SUBJECT: Forwards draft response to NRC Question 130.050 (turbine missile study) & revised FSAR pages. All encl info will be incorporated into Amend 23.

Subject: NUCLEAR PROJECT NO. 2  
NRC QUESTION 130.050  
TURBINE MISSILE STUDY

Q. 130.050  
(Q220.001)  
(3.5.1)

FIGURE  
3.5-33

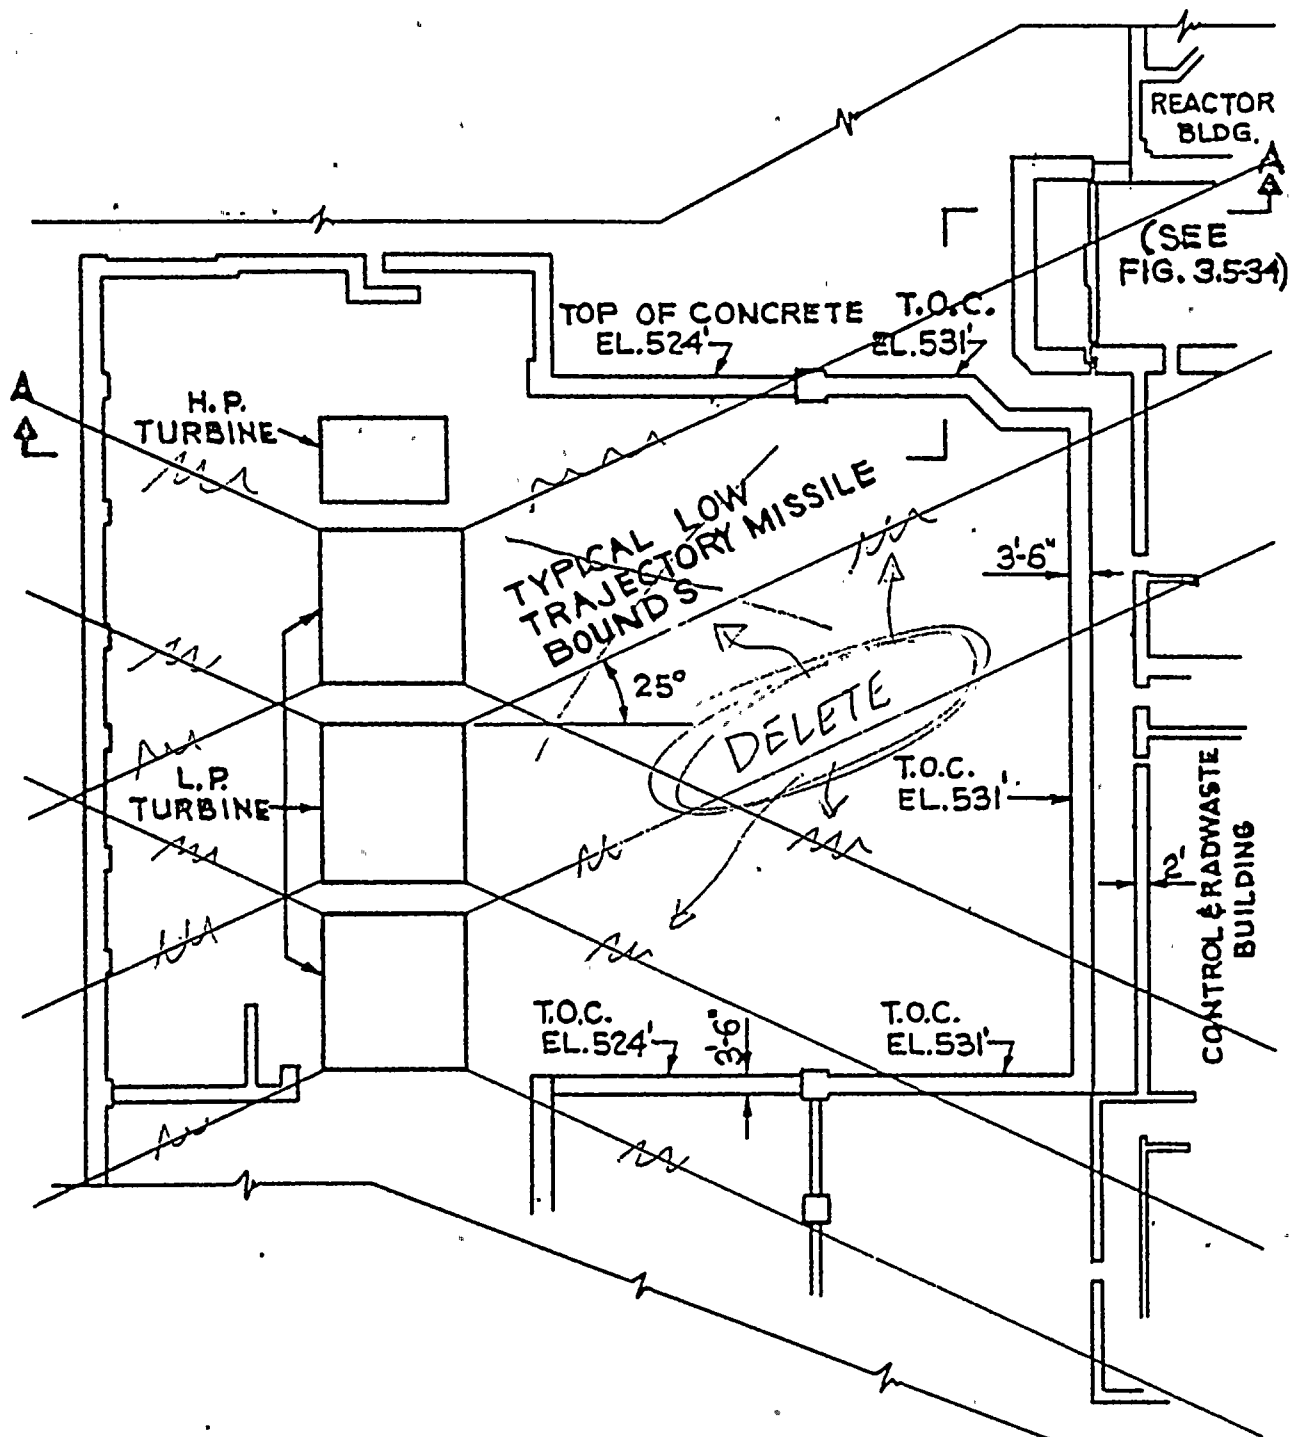
( Deleted )

—LOW-TRAJECTORY-MISSILES  
—AT-CATASTROPHIC-FAILURE  
—SPEEDS-181% DESIGN-SPEED

Figure 3.5-33 shows the turbine generator layout relative to safety-related plant structures and turbine missile target areas. Also shown on this drawing is the reinforced concrete shield wall which acts as a barrier for protection of some safety-related targets from postulated low trajectory turbine missiles. A cross-sectional view through the turbine building and reactor building is shown in Figure 3.5-34 to indicate relative elevations of the turbine and target areas. See Figure 1.2-5 for a general arrangement drawing of the turbine building, reactor building, and control building at the turbine operating floor elevation.

FIGURE  
3.5-34

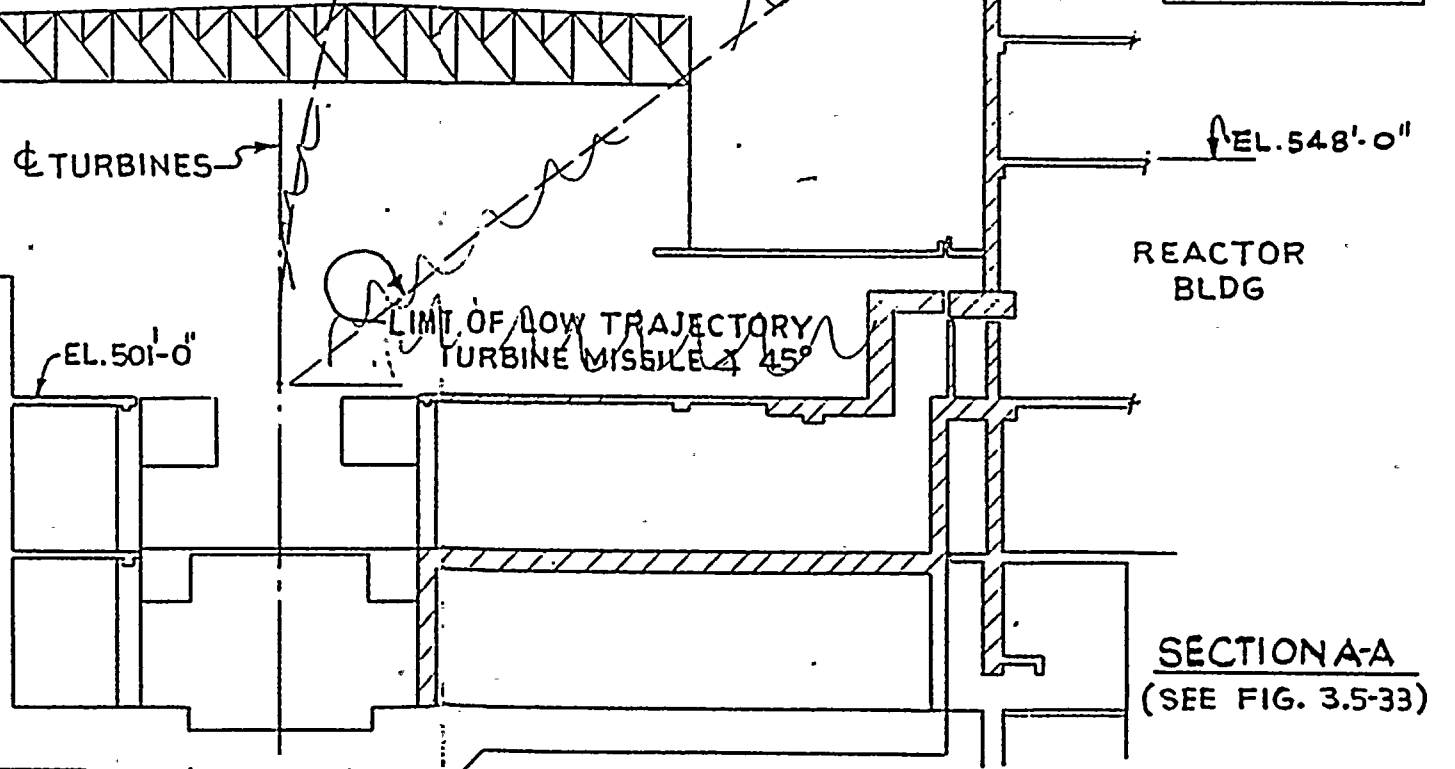
DELETE

~~FURTHER~~  
TURBINE MISSILE BARRIERS
